Newleaf Bonnyrigg - Response to Submissions

Section 75W Application (MP06_0046)

April 2012

FIGURE 1 – LAND USE MAP – DECEMBER 2011 (PROPOSED)

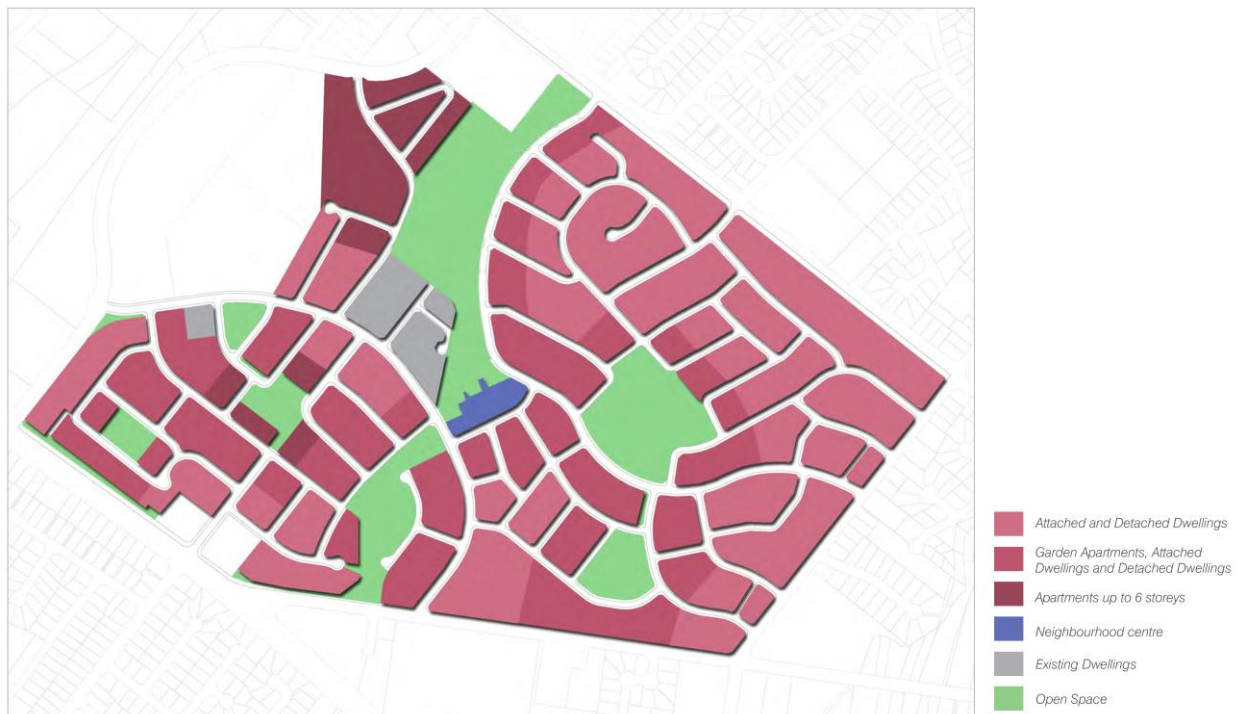
Council has requested that the criteria location for apartments be changed so that these structures can only be provided '*directly opposite public open space or the community facility precinct*'.

Bonnyrigg Partnerships considers that the current controls are entirely appropriate and do not need to be modified. It is our view that it is appropriate to allow for garden apartments to be provided in close proximity to Bonnyrigg Plaza, as well as open space and the community facility precinct. The revised Land Use Map clearly shows where garden apartment can be located in areas which benefit from a higher level of residential amenity. This includes sites which are in close proximity to services and public transport and are appropriate for higher density development.

Further, it is our view that the proposed terraces/row houses should not be restricted in terms of their location but can be provided across the residential estate, similar to the current provisions for 4, 6 and 8-plex attached dwellings which are of a similar or higher density.

FIGURE 3 – ROAD HIERARCHY MAP – DECEMBER 2011 (PROPOSED)

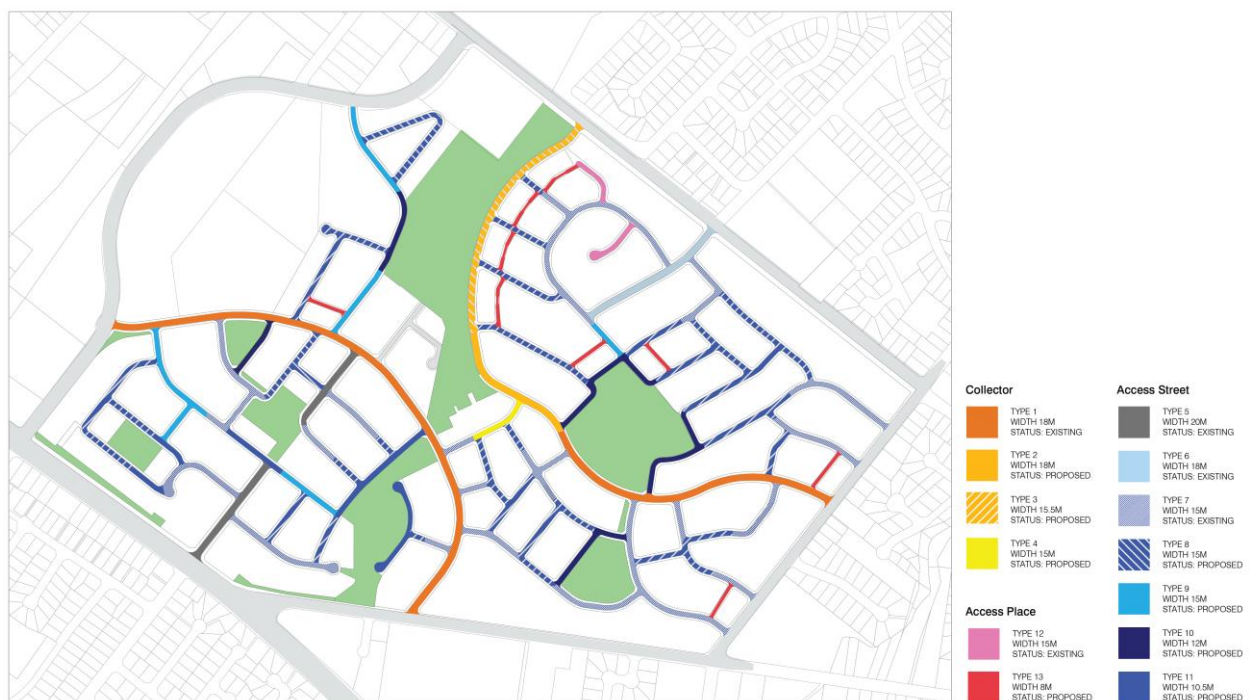
The Bonnyrigg Private Homeowners Group and two of the private land owner submissions have raised concern with regard to the opening up of cul-de-sacs across the estate.

The Section 75W application proposes only minor modifications to the approved road layout, taking into account the reconfiguration of the public open space and the staging boundaries. The approved and the proposed Road Hierarchy Plans are shown in the figures below. It can be seen that there are no

significant changes to the road layout in the immediate vicinity of the private owners who have made submissions in response to the proposed modifications. Further, there are no substantive changes to the original approved layout that impact on the issues raised by the Bonnyrigg Private Homeowners Group.
